**Project #20-012  
Cardall Metal Buildings  
Located at 1340 W 250 N**

*Project Name:* Cardall Metal Buildings  
*Proponent / Owner:* Courtney Wallace (Cartwright AEC, Inc)/Valley View Business Complex LLC  
*Project Address:* 1340 W 250 N  
*Request:* Design Review Permit  
*Current Zoning:* Commercial (COM)  
*Type of Action:* Quasi-Judicial  
*Hearing Date:* February 27, 2020  
*Submitted By:* Aaron Smith, Planner II

Staff recommends that the Planning Commission **conditionally approve** a Design Review Permit for Project #20-012, Cardall Metal Buildings, for a 12,800 SF and a 6,720 SF industrial building at 1340 W 250 N, TIN #05-100-0004;-0005;-0006;-0007.

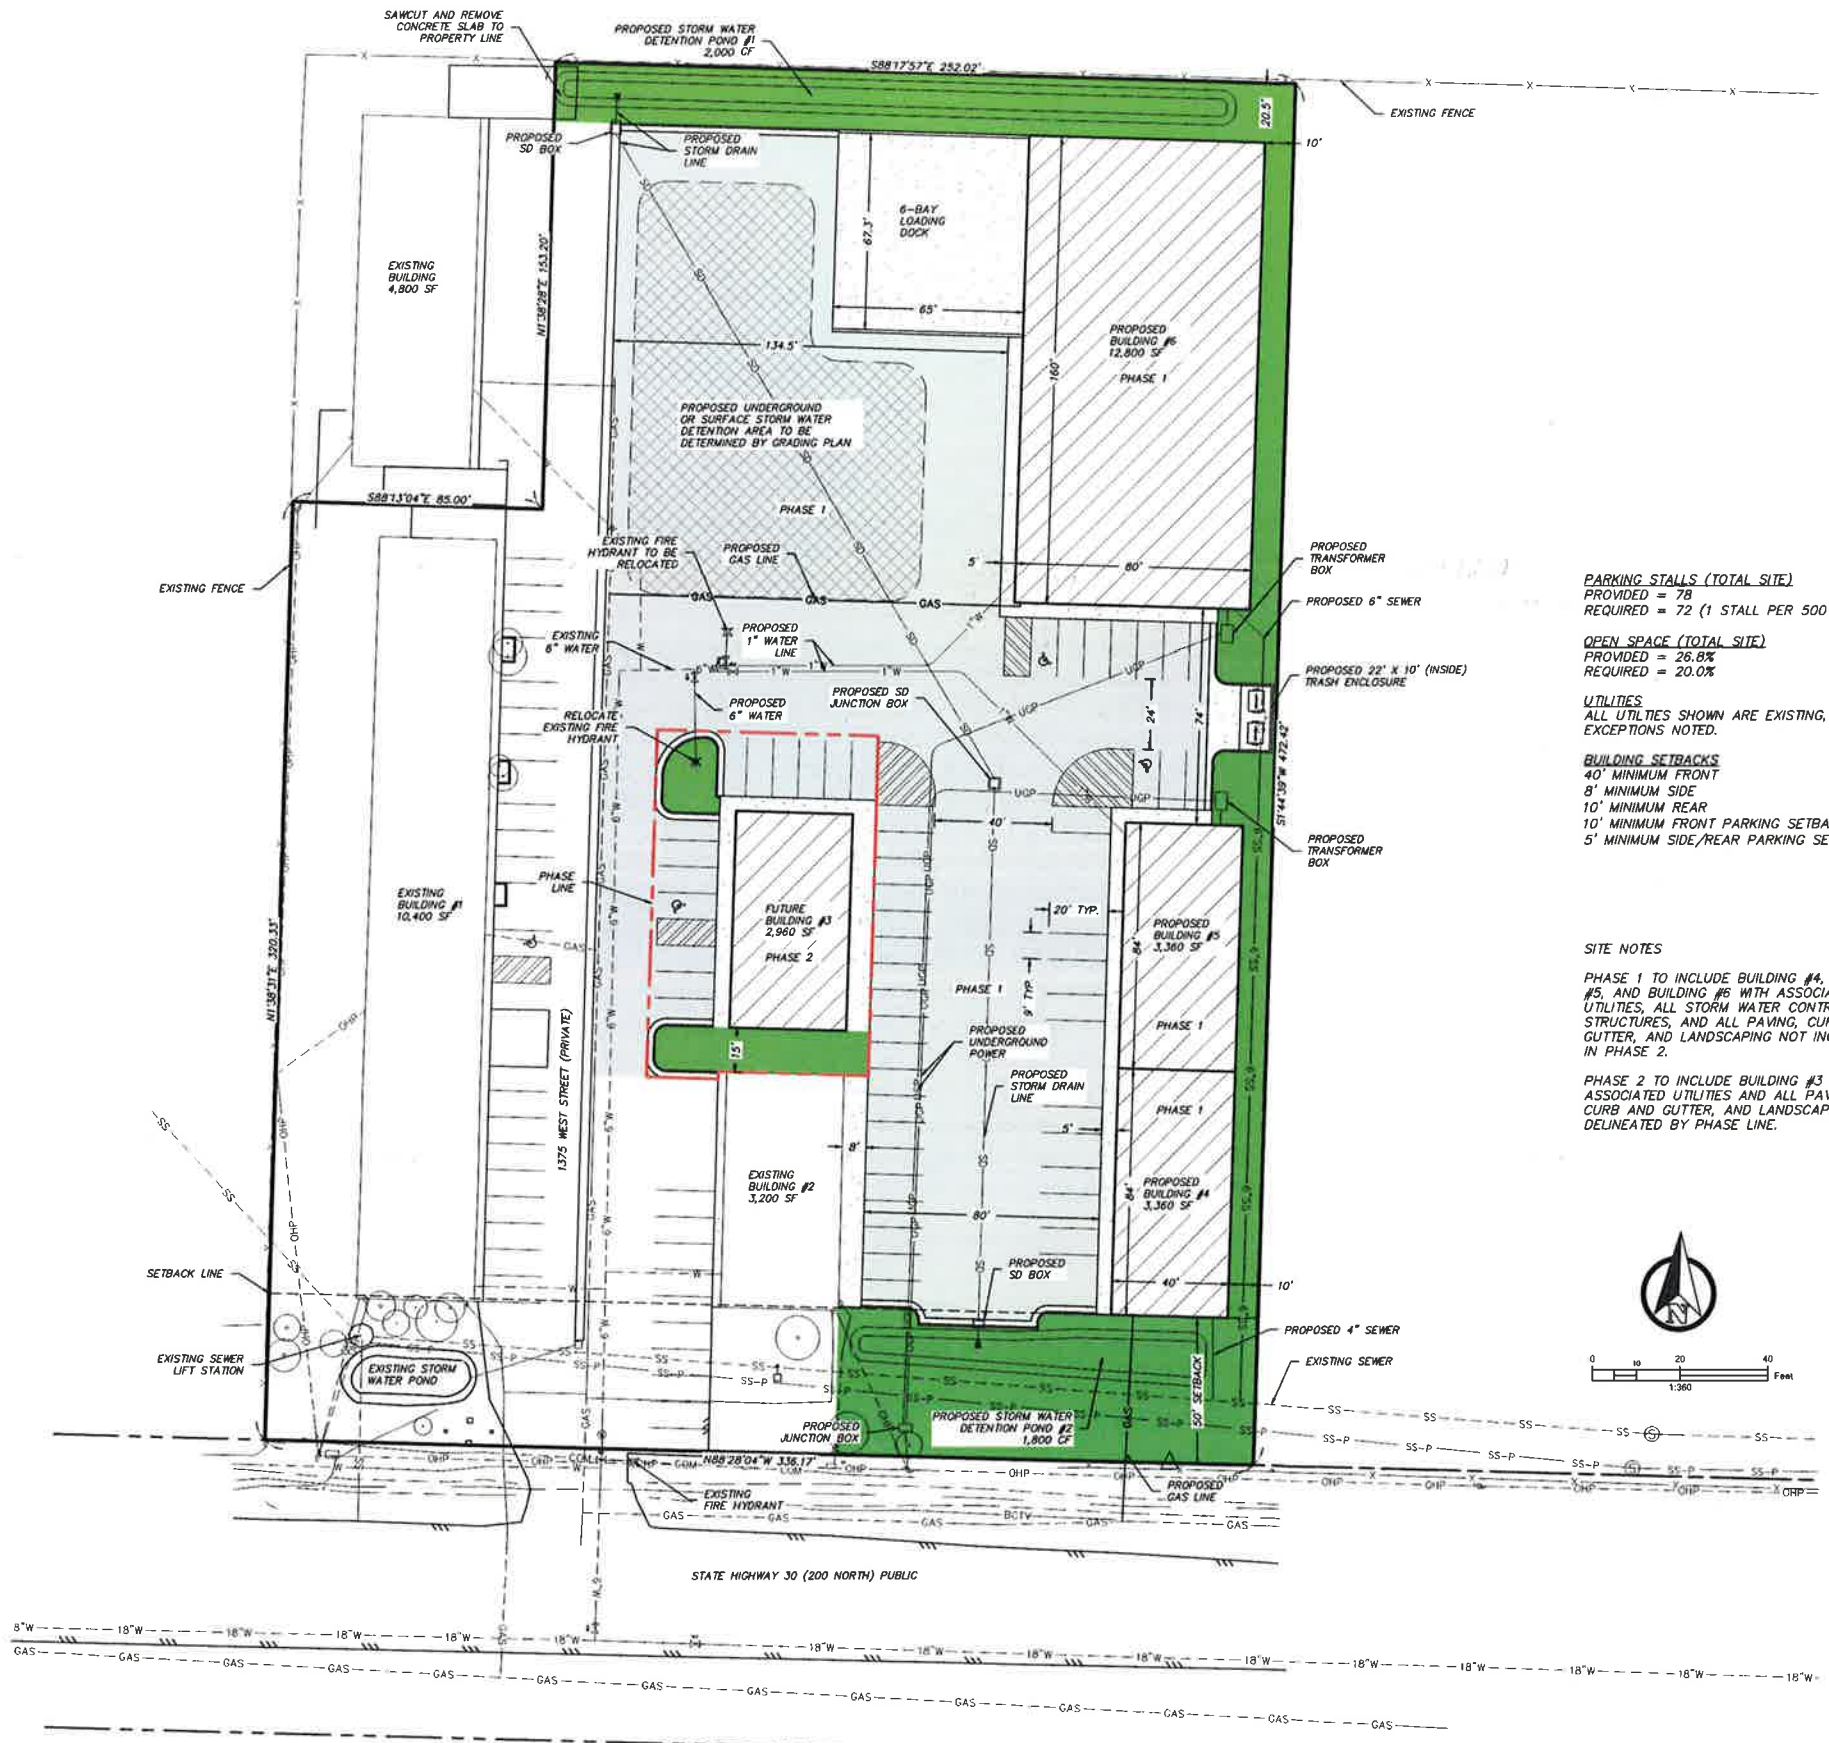
The buildings are designed to be flexible in use to accommodate various tenants. As the parking is shared between tenants, total parking calculations include proposed and existing buildings (36,080 SF). For industrial uses, the LDC requires various parking standards, such as one stall per every 500 SF of shop space, one stall per every 1,000 SF of industrial service space, 3 stalls per every bay door for vehicle repair, and one stall per every 2,000 SF of warehousing space. The site plan includes 78 parking stalls, which is a ratio of one stall per 462 SF. The proposed ratio is lower than the most restrictive potential use for shop space of one stall per 500 SF. Staff's review of the proposed parking is that it is substantially compliant with parking standards. Truck/trailer parking is not indicated on the site plan. Current use at the site shows truck/trailer use. Truck/Trailer parking should be in striped area and not block drive aisles for the site. As conditioned, with 78 on-site parking stalls and truck/trailer parking areas marked, the project complies with the requirements in the LDC.

The LDC requires 10% open space and an additional 10% useable outdoor space in the CS zone. The LDC generally describes open space as native vegetation or landscaped areas, while useable outdoor space could consist of additional landscaping, decks, patios and walkways, but shall not include parking, driveways and storm-water facilities. The project area (98,000 SF) would require 9,800 SF of both open space and usable outdoor space for a total of 19,600 SF. The proposal includes conceptual open space and usable outdoor areas. The project proposes approximately 20,000 SF of total open space and usable outdoor space. Final measurement of open space and usable outdoor space is done with the submission of the planting plan with the building permit. As conditioned, with a landscaping plan that delineates open space and usable outdoor space, the project complies with the requirements in the LDC.

Generally, surface storm-water retention and detention facilities should not be located in front yard areas. The proposed plan includes a detention area adjacent to the highway. Detention basins that are located in areas that are visible from the public street are required to be landscaped to provide an amenity to the development and utilize landscaping materials that reflect the natural traditions of Logan. As conditioned, with a landscaped detention area, the project complies with the requirements of the LDC.

5. 78 parking stalls are required.
6. Truck/trailer parking shall be marked and not block drive aisles.
7. A performance landscaping plan, prepared in accordance with §17.32 of the LDC, shall be submitted for approval to the Community Development Department prior to the issuance of the building permit. The plan shall include the following:

- a) A minimum of 9,800 SF of both open space and usable outdoor space, for a total of 19,600 SF, shall be provided
  - b) A total of 44 trees and 110 shrubs, flowers and ornamental plants shall be provided.

- h) Surface storm-water retention and detention facilities that are located in areas that are visible from the public street shall be landscaped to provide an amenity to the development and utilize landscaping materials that reflect the natural traditions of Logan.

**A3 EAST FACING EXTERIOR ELEVATION**  
SCALE: 1/8" = 1'-0"

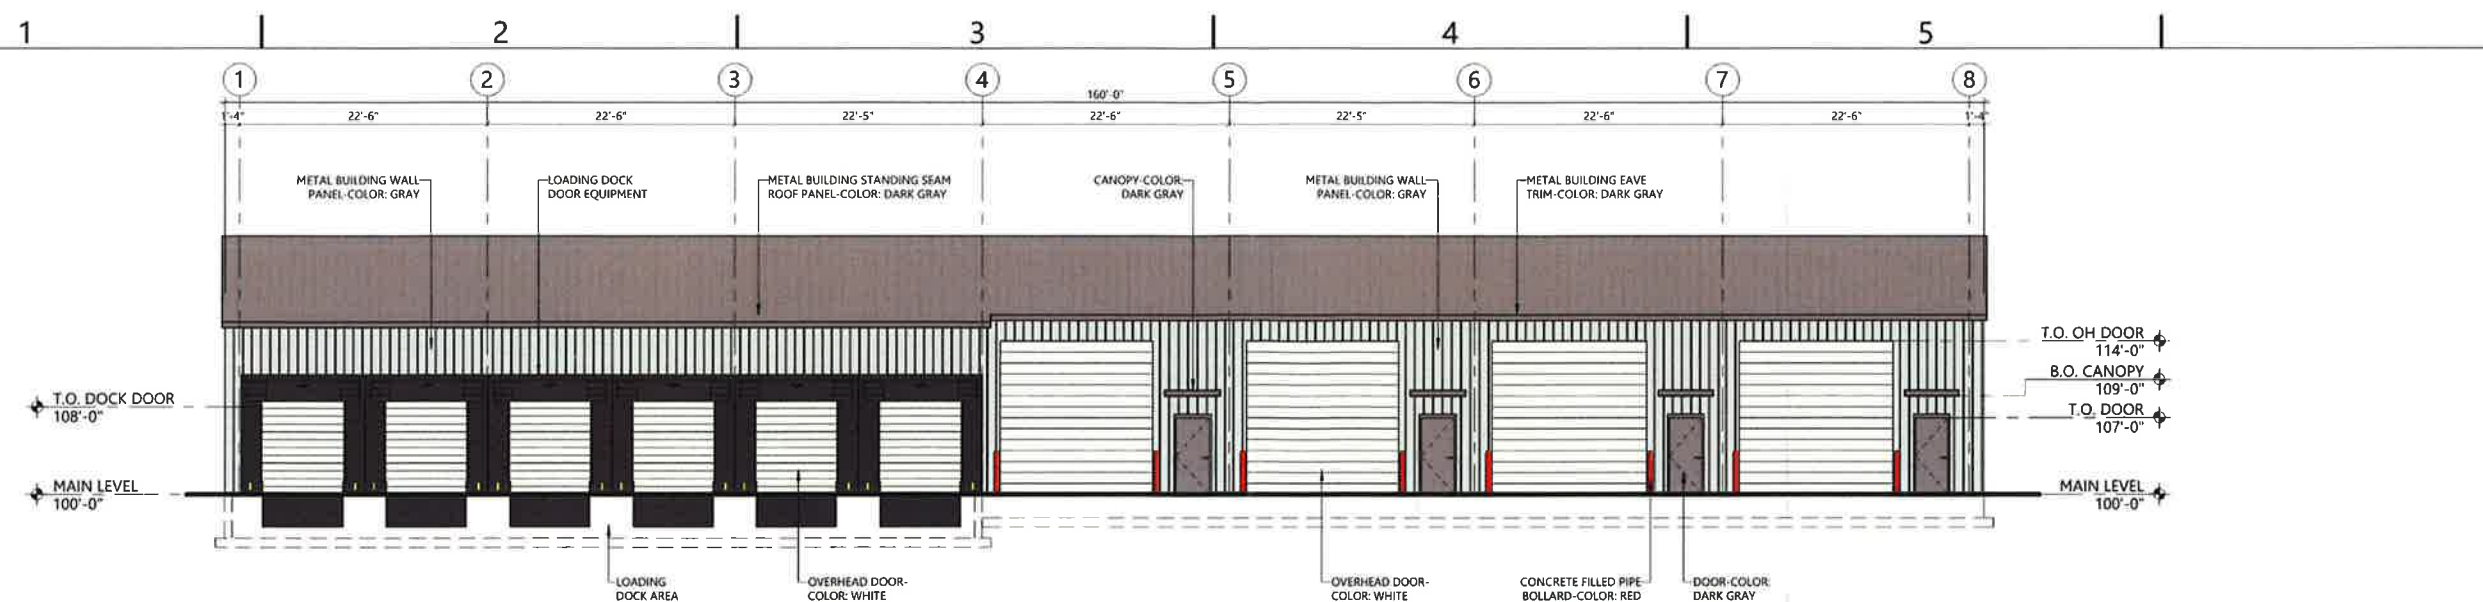
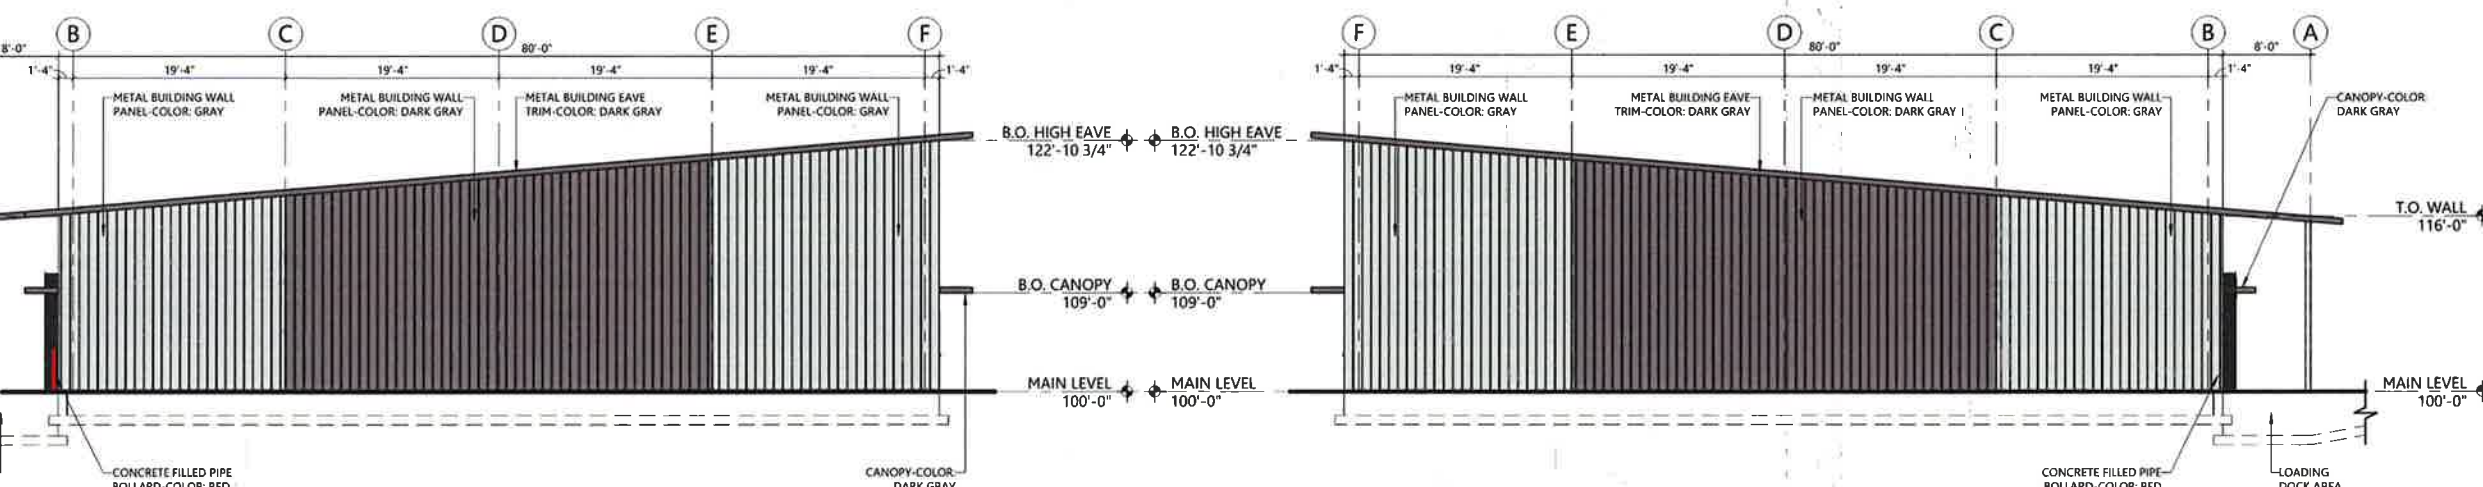
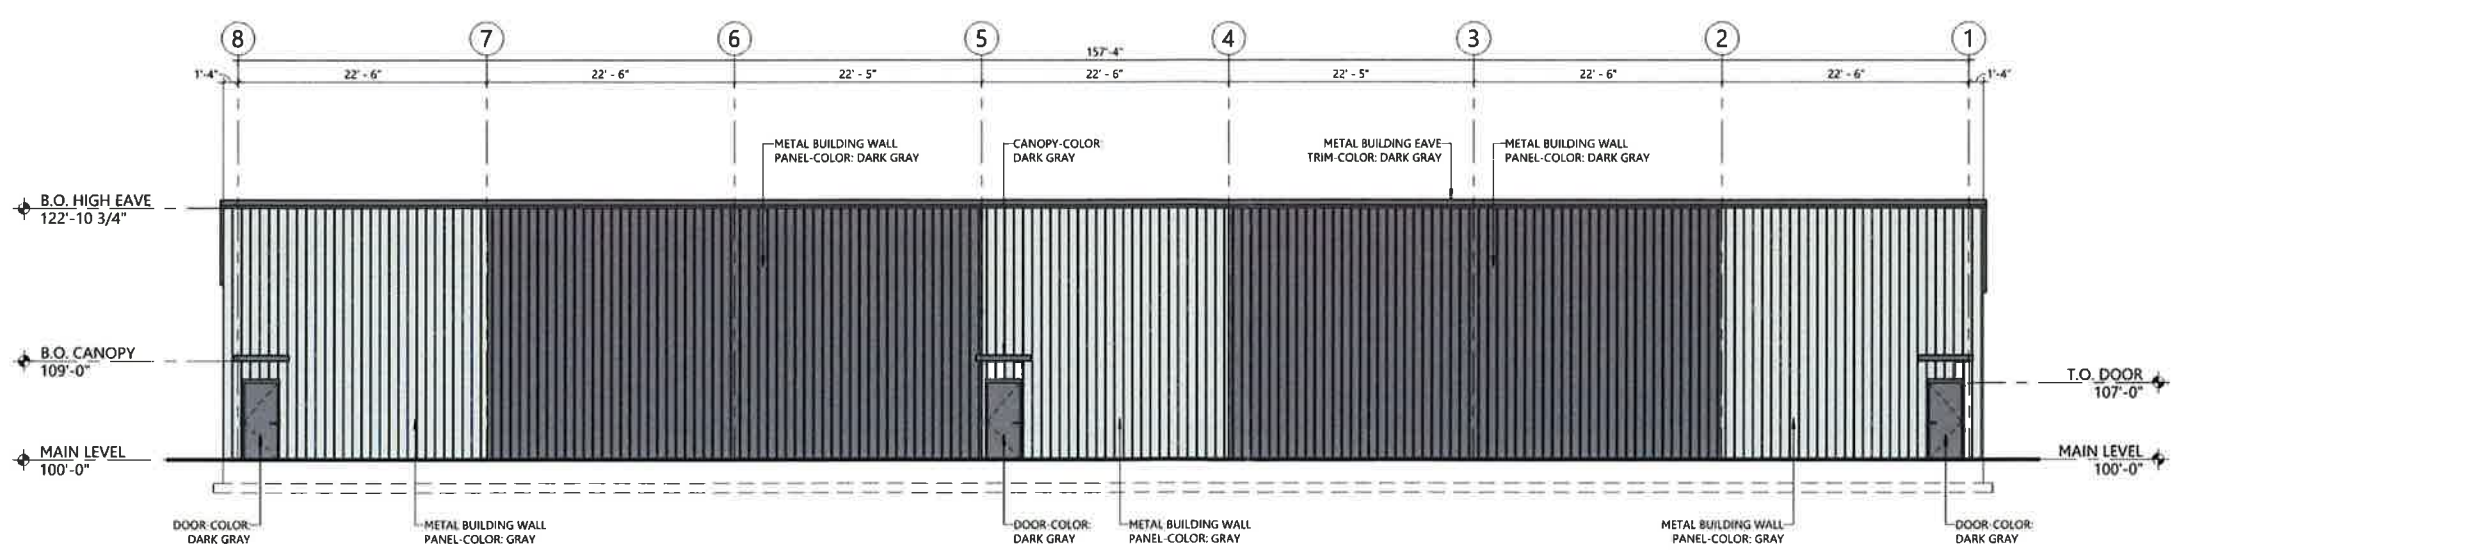
The CS standards require minimal building form features to break-up building mass and scale. The LDC states that blank walls greater than 40' are not permitted along facades visible from a public street, and that two methods must be used to create interest and reduce scale. Methods mentioned in the code include staggering of vertical walls, recessing openings, providing upper-level roof overhangs, using deep score lines at construction joints, contrasting compatible building materials, and using horizontal bands of compatible colors. The east elevation provides contrasting colors, but a second method along the façade for both the south and north buildings is required. Staff recommends that vertical landscaping be utilized along these facades to break up the form, as a plant strip is required along these facades. As conditioned, with a second method for breaking up building mass along the east facades of the proposed buildings, the project complies with the requirements of the LDC.

9. The east elevations of new buildings shall include at least two methods to break-up monotonous building design.
10. Building entrances along the west elevation of the southern building that are visible from the public street shall have a minimum off-set of 4'.
